RIKEN KIKI CO.,LTD.

Notice of the production end articles

① Sub plate Type :**R-44-BP**

General view

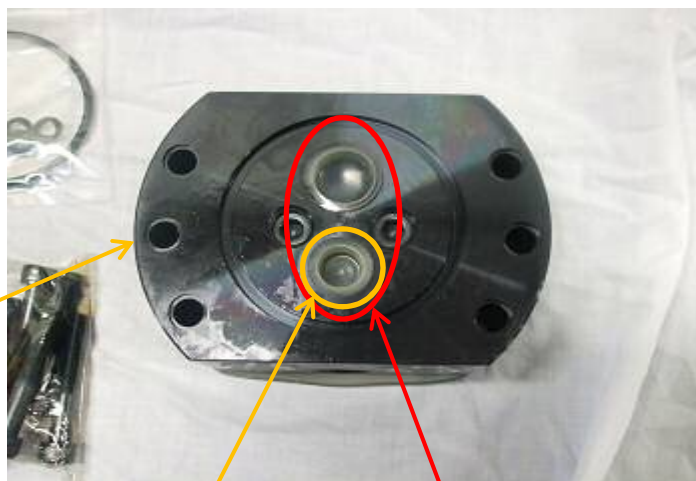
● R-44-P can be compensated as alternate product. Refer to the following pages.

Open this ports

There is no port.
R-44-P has T port.

This port size is Rc3/8.
(The same port of R-44-P is Rc1/2.)

Close these ports by plug
